## LiDAR Quality Assessment Report

### SD\_Missouri-River-Lidar-Dewberry-B2\_2016

NGTOC

2018-06-28

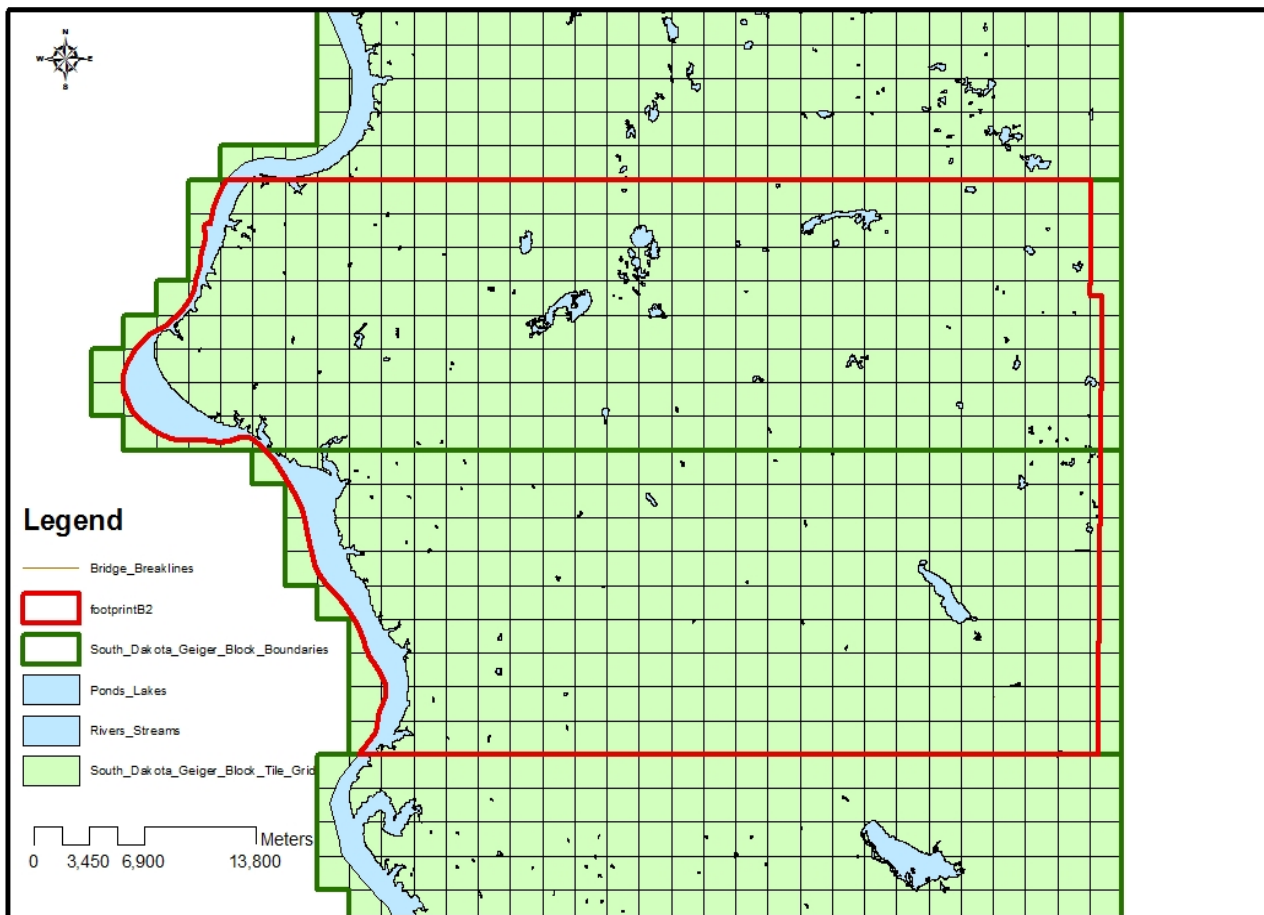
Please supply block and project boundaries that reflect the provided data extends (delineated in red).

Corrections were provided on 09/11/2018: This issue was not addressed. The correction files were delivered collectively.

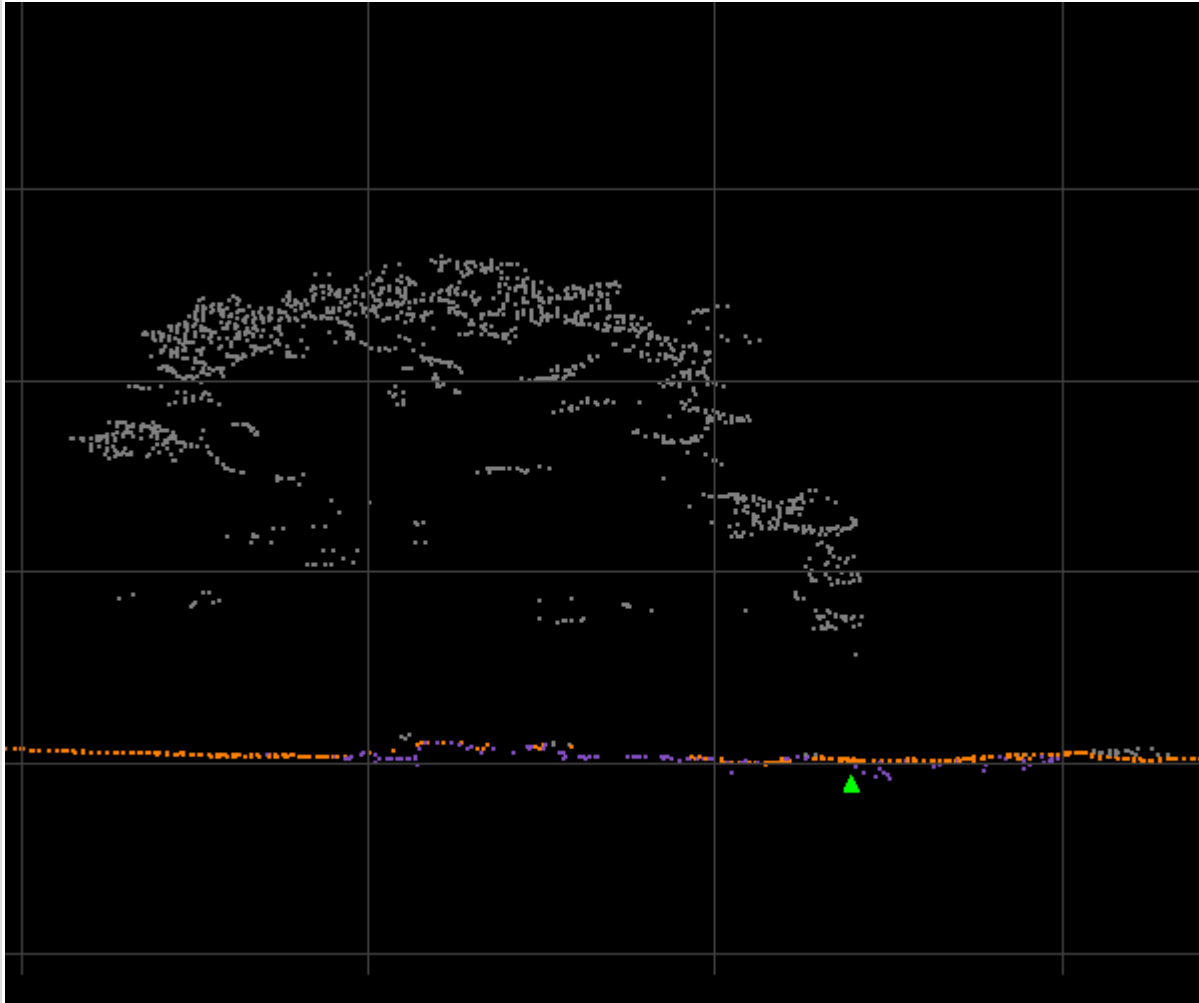
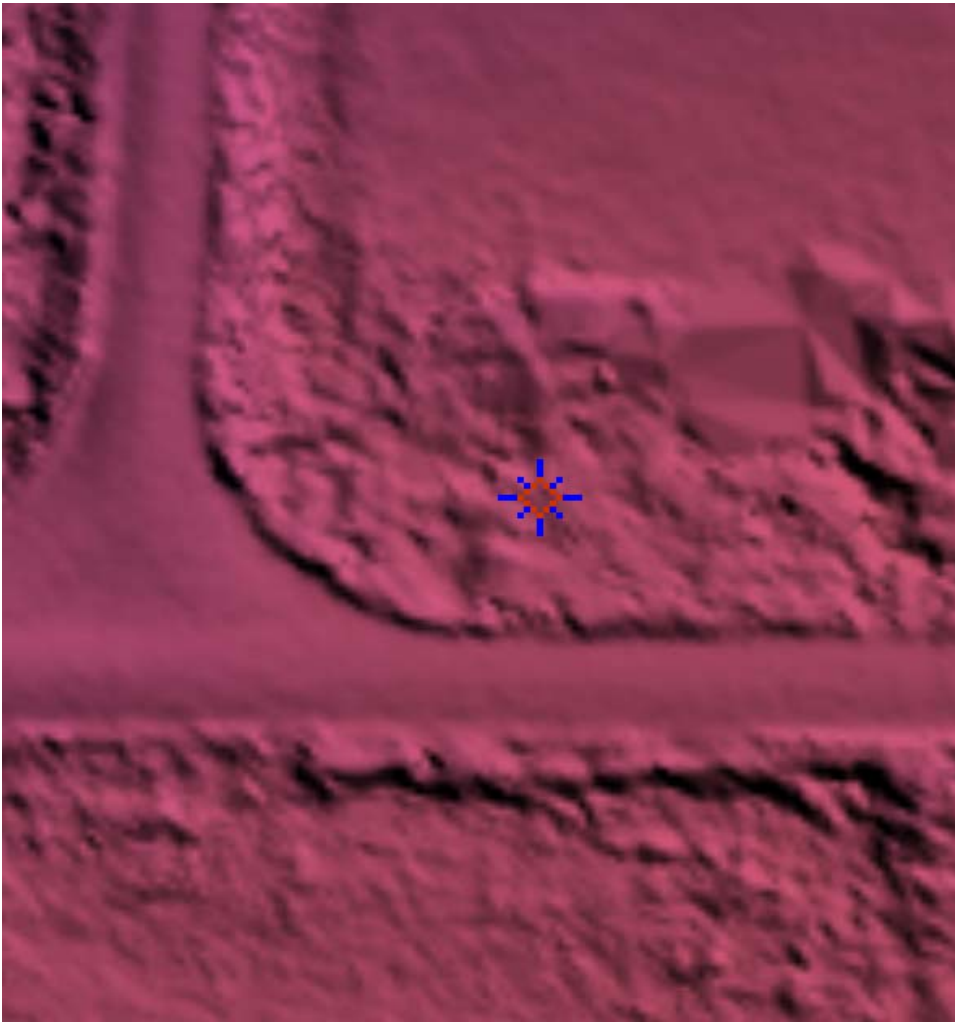
The dataset includes additional Non-vegetative Vertical Accuracy (NVA) and Vegetated Vertical Accuracy (VVA) checkpoints. Namely, for the required 166 NVA checkpoints 171 points are provided. In addition, for the requested 119 VVA points, 130 points were supplied. All of the provided VVA checkpoints (130) were tested. The project does not meet VVA standards for the digital elevation model (DEM) data.

The image below reveals the vertical location of VVA-109 check point in relation to the point cloud. The subsequent image captures the same point as compared to the DEM. The calculated elevation difference for the point is 82.2406 centimeters.

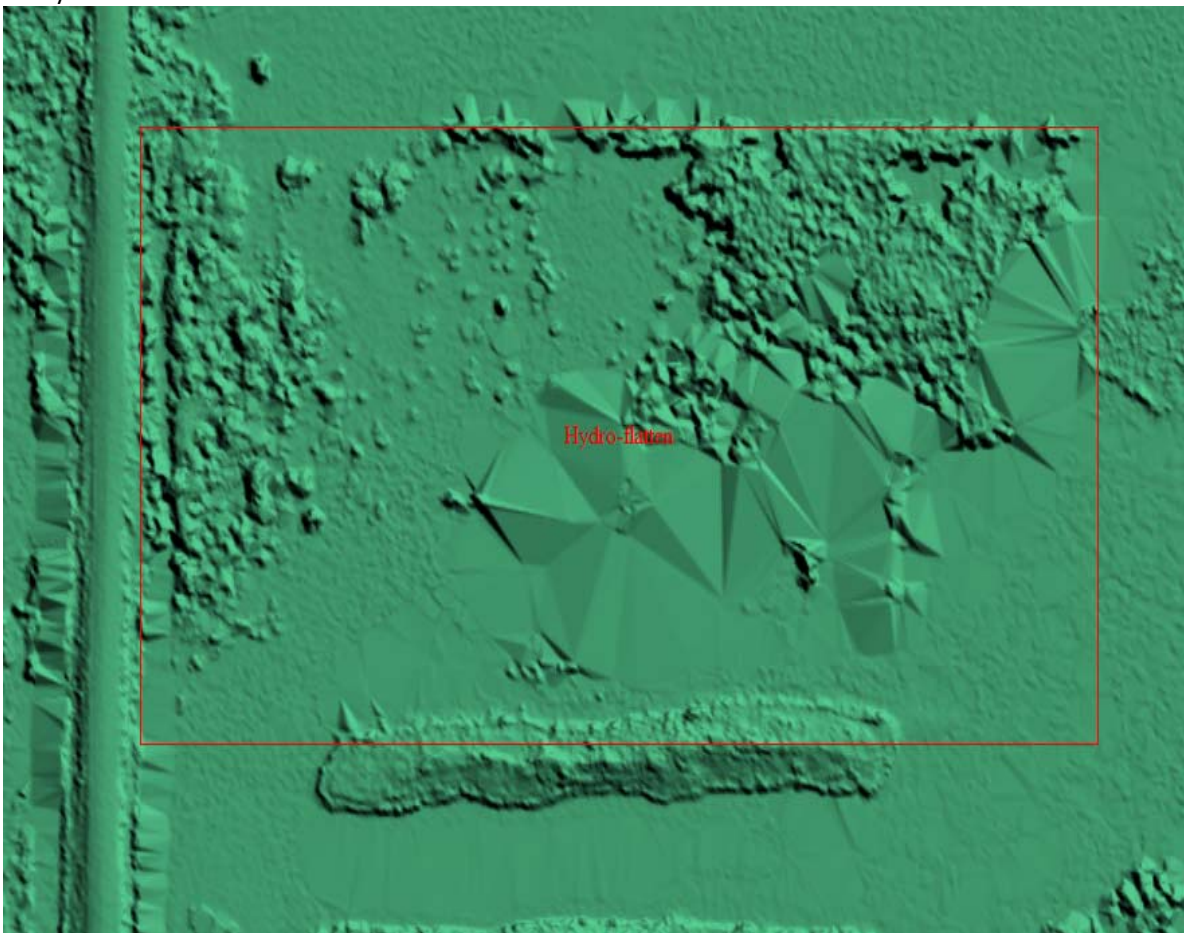
The digital elevation model (DEM) presents some pixel size voids. Two areas have been identified.

Corrections were provided on 09/11/2018:  
The identified features have been modified.

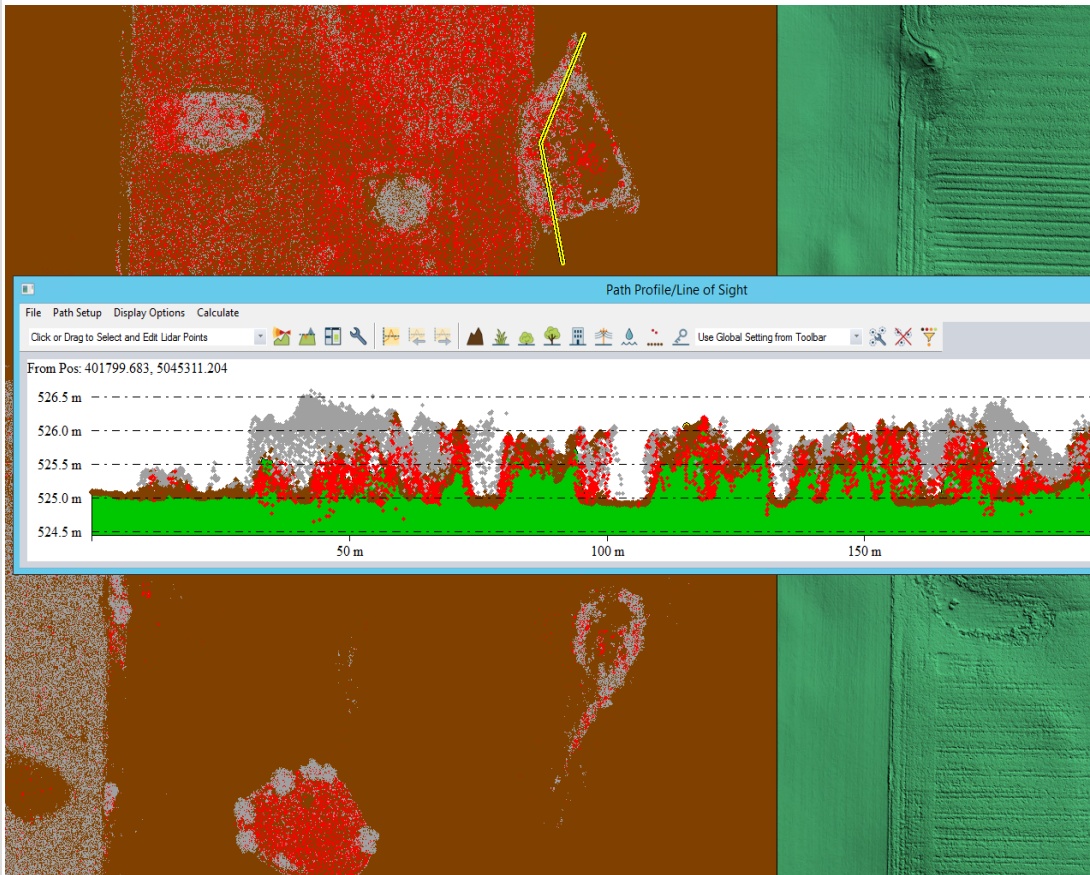
Thirty-three areas of concern have been identified.

Corrections were provided on 09/11/2018:  
The above-mentioned issues have been appropriately addressed.

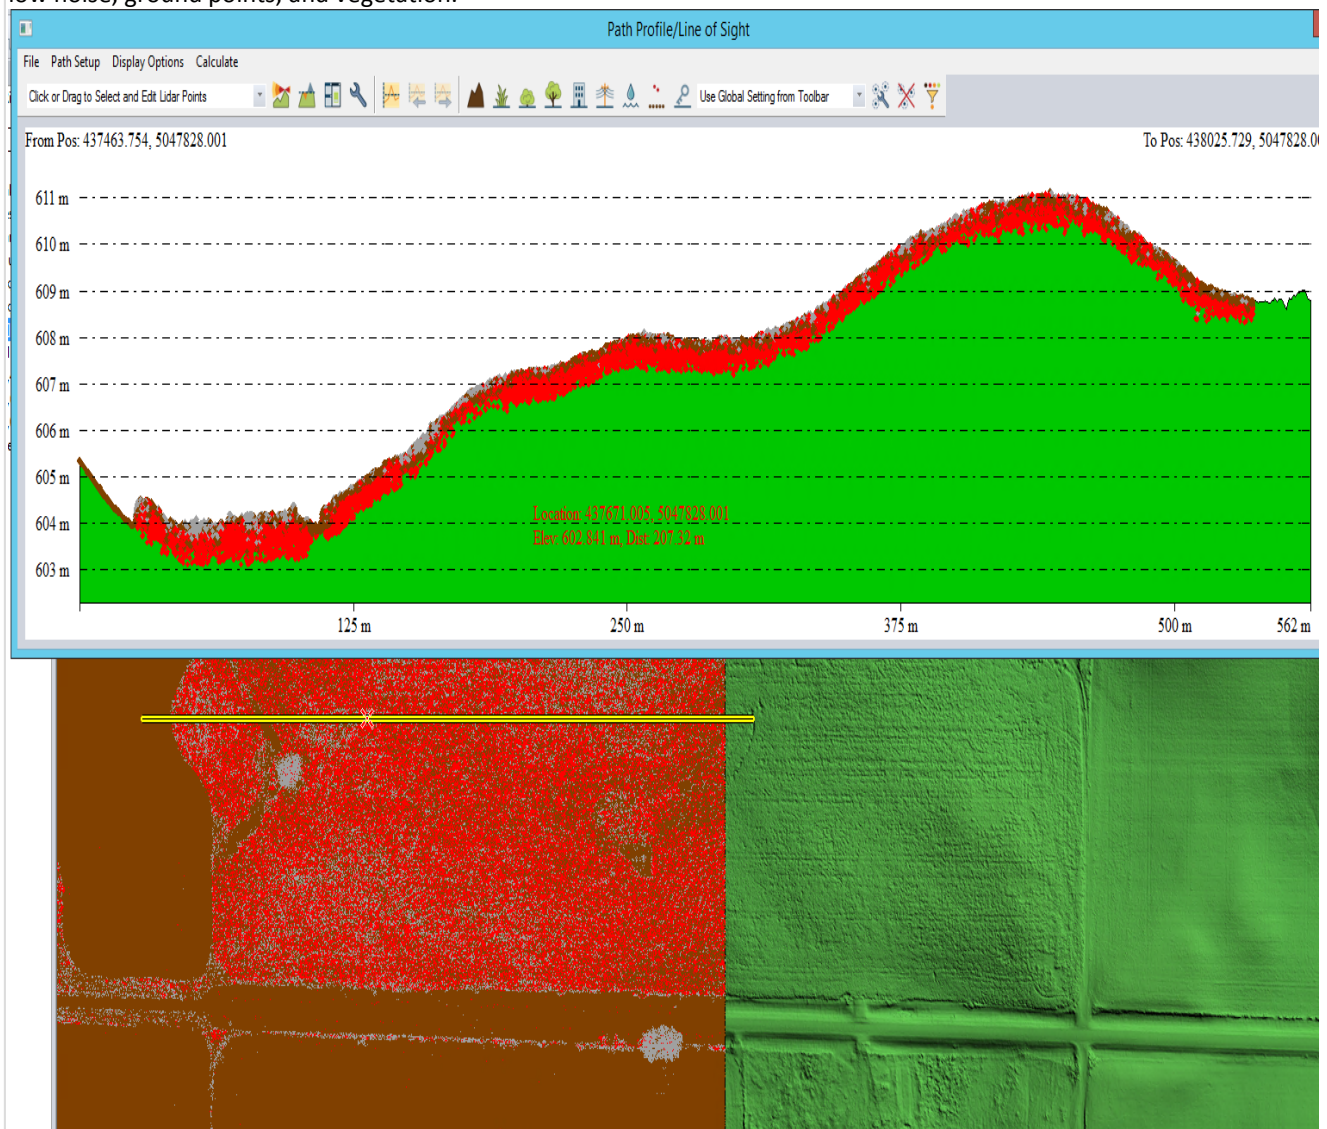
Please remove vegetation artifacts and identified noise/ground/unclassified point distribution errors. Eight areas of concern have been identified.

In addition, please review six spaces where tinning due to limited ground points has been located.

**Locations are not limited to those identified in the report and within the error files. The shapefiles are only representative of the error. This issue is endemic throughout the data set.**

**Corrections were provided on 09/11/2018:**

- The identified features have been improved.
- Gdal reading of the WKT dialect is slightly different for redelivered raster tiles.

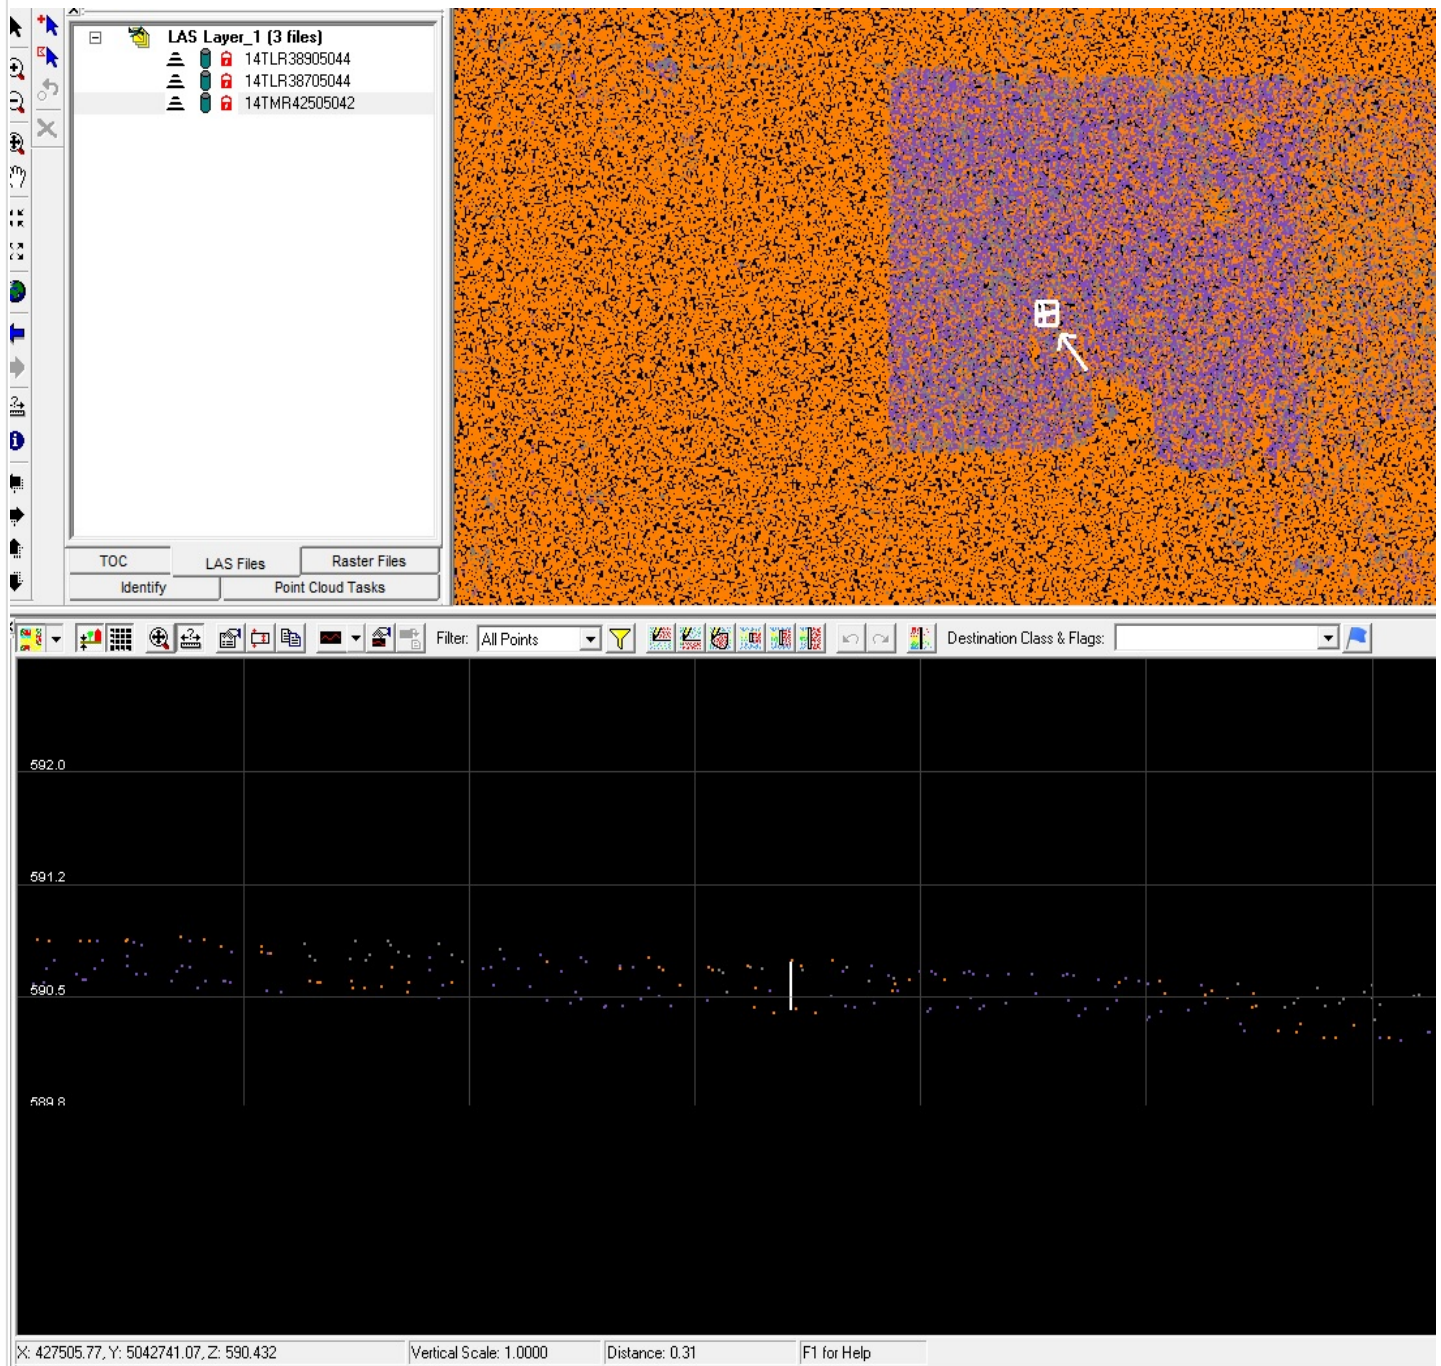
In addition, some of the ground points suggest a concentrated point cloud delineating the surface, beyond a customary (couple of centimeters high) vertical distribution. It is anticipated that the ground points would be horizontally densely populated; however, it is unexpected for the cross-section to reveal a thick profile of the ground points.

The following image shows an example of an area drawn at one meter depth, where the difference between the highest and lowest ground point is thirty one centimeters. The area was chosen at random and does not represent the lowest or highest vertical distance between the ground points.

This raises a concern in terms of the accuracy the constructed digital elevation model, especially in areas exhibiting low vegetation. This seems to be line with the vertical accuracy results presented by Dewberry (2018). Yet, this review did not anticipate that the appearance of the DEM would be altered in a manner that is visually detectable. Currently, several areas exhibiting puzzling features have been identified.
